**PLANNING COMMISSION REPORT
REGULAR AGENDA -- PUBLIC HEARING ON VARIANCE AND WAIVER REQUESTS ONLY**

ITEM NO. 3C: VARIANCE & WAIVER FOR MAPLE LEAF SQUARE ADDITION (MKM)

ITEM NO. 3D: PRELIMINARY PLAT FOR MAPLE LEAF SQUARE; 4145 SEELE WAY (MKM)

PP-10-13-08: Preliminary Plat for Maple Leaf Square, a 10.24 acre subdivision consisting of 41 lots, located at 4145 Seele Way. Submitted by Landplan Engineering PA, for Doolittle Farms LLC, property owner of record.

Figure 1. Subject property and surrounding road network.

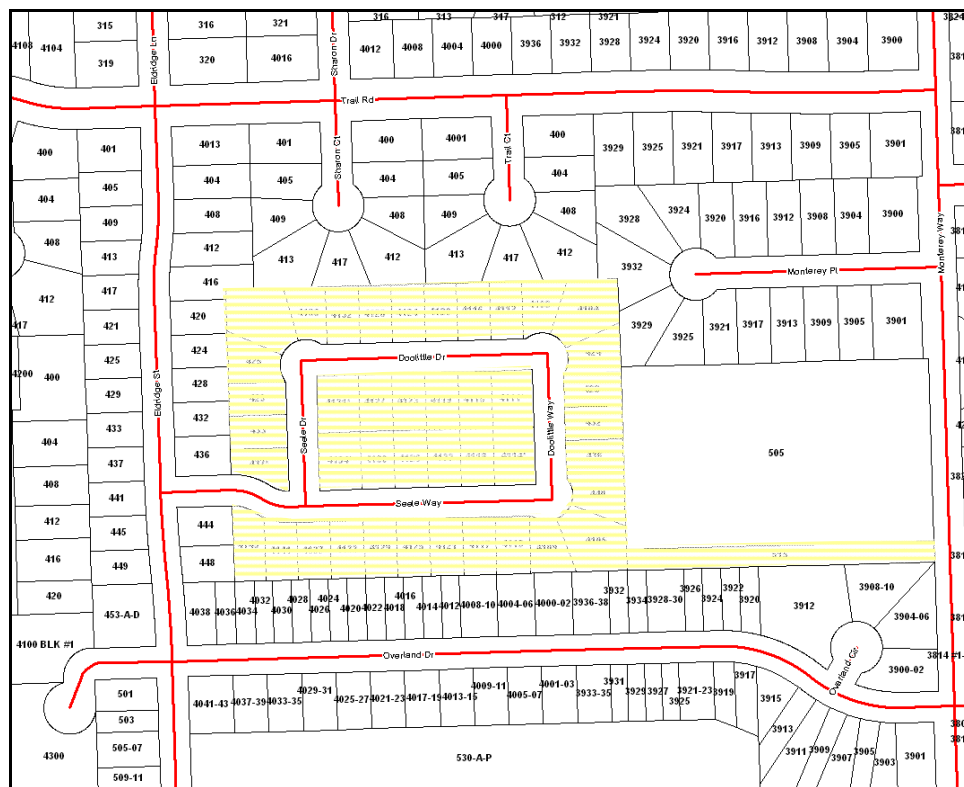
Property surrounding the subject property developed earlier than the subject property. The property to the west, north and south was platted in 1989 as Monterey Subdivision No. 1. The properties to the east were platted in 1983 and 1994. The subject property was relatively land-locked as a result of the surrounding development. (Figure 1)

Figure 2. Detail of Maple Leaf Square preliminary plat showing sidewalk on the south side of the street and street right-of-way. Area with narrower right-of-way is marked with a star.

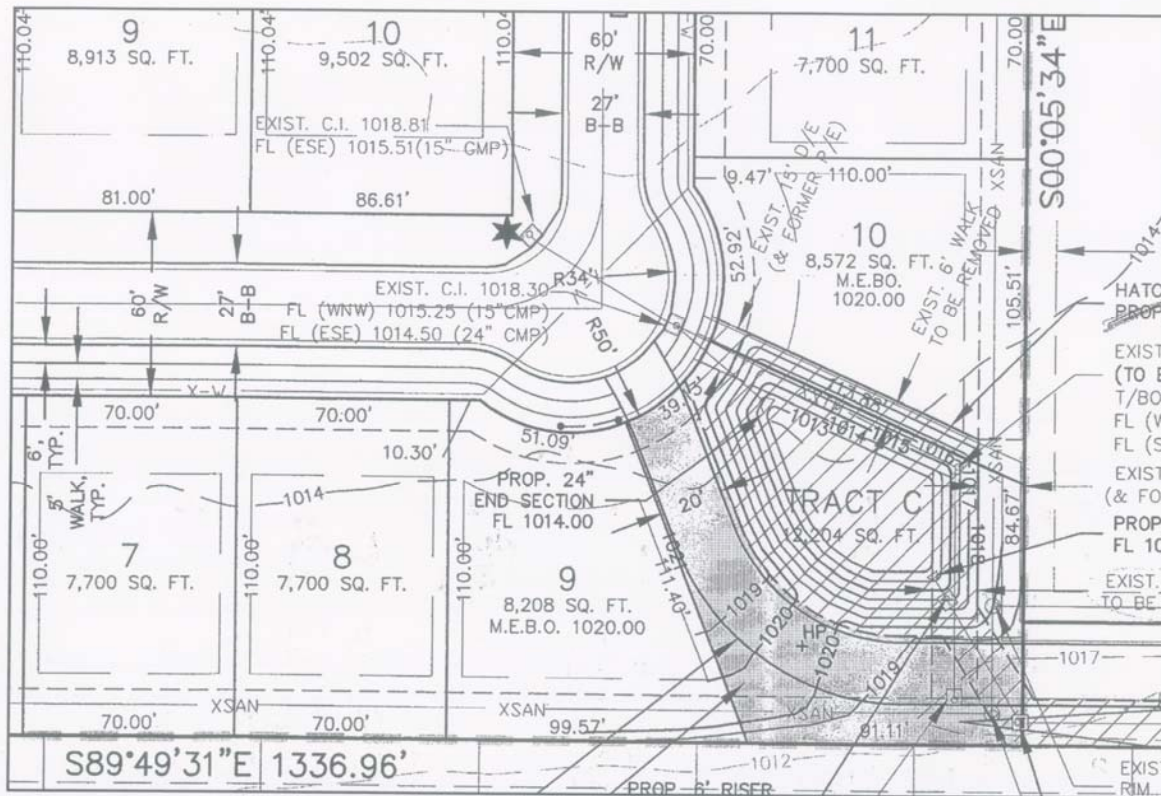
The Subdivision Regulations require sidewalks to be constructed on both sides of the street so that it is not necessary to cross the street to access a sidewalk. 10 duplex lots would have a total of 20 dwelling units, which is nearly 1/3 of the total number of dwelling units proposed. Duplex zoning permits a maximum of 4 unrelated adults per dwelling units; therefore, it is possible that up to 80 adults and their children could be affected by the lack of sidewalks in this area.

The plat shows 60 ft. of right-of-way existing for the streets within the development. The streets measure 27 ft. back to back of curbs and there is 33 ft of right-of-way remaining which is located on each side of the street. A 5 ft. wide sidewalk is shown on one side of the street's right of way approximately 6 ft. from the curb line. As an equivalent amount of right-of-way is provided on the other side of the street, a sidewalk would be able to be constructed without creating an unnecessary hardship on the applicant. The corners of the block are angled and it may be necessary to angle the lot lines for the corner lots to provide the required area for the sidewalk and the separation from the street. (Figure 2) The requested waiver fails to meet the ‘impractical or difficult to build’ criteria used for waivers allowing sidewalks to be constructed with less than the required width.
